## **ATTACHMENT 2**

Government Authority Responses to Request for Key Issues

**Response to Notification of Request for SEAR's: SSD-18406916–  
Warehouse and Logistics Estate including Bulk Earthworks, Infrastructure  
Delivery and Road Access – 1953 – 2109 Elizabeth Drive. Kemps Creek**

**1953-2109 Elizabeth Drive (SSD-18406916)**  
**Comment on the Secretary's Environmental Assessment Requirements (SEARs)**

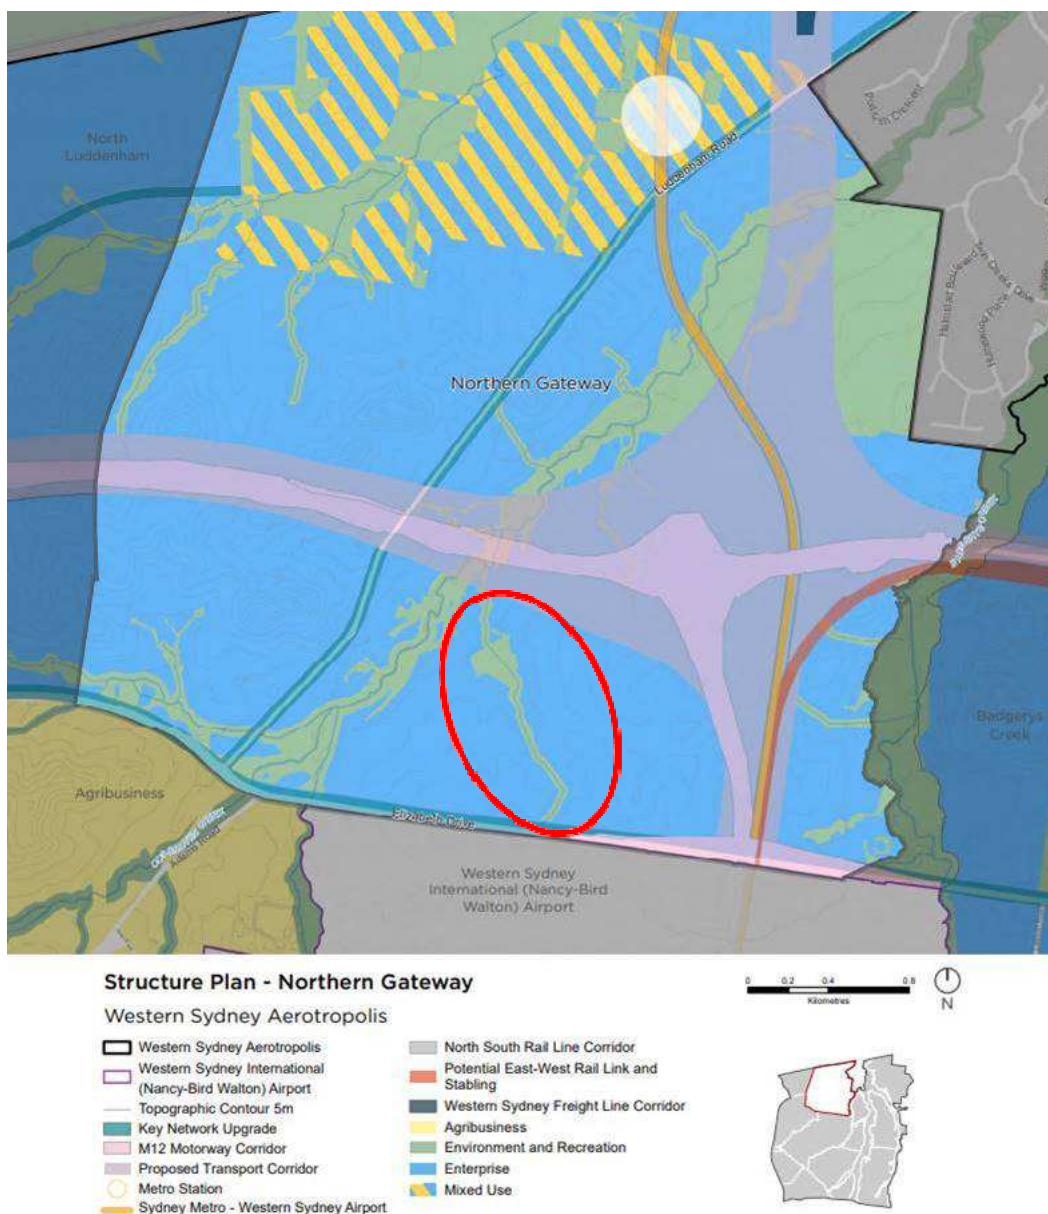
Land use framework – while the Aerotropolis SEPP is the EPI that gives effect to the rezoning of the site to a mixture of Enterprise and Environment and Recreation, the WSAP also foreshadows these land use zones. As highlighted in the image below, this includes flagging a strip of land running through the subject site as Environment and Recreation. The staged structure plan in the scoping report includes this area as part of the general developable footprint of the site which is inconsistent with the WSAP. Further, the proposed transport corridors running through the site are substantially reduce and also requires concurrence from TfNSW for any planned development in this footprint, as is proposed in the structure plan presented (as per Clause 29 of the Aerotropolis SEPP).

Any proposal for the subject site would need to demonstrate how the proposed development gives effect to each of these 11 objectives, including outlining how any aspects of the proposed plans may differ from the planning framework for the area, to better achieve these objectives.
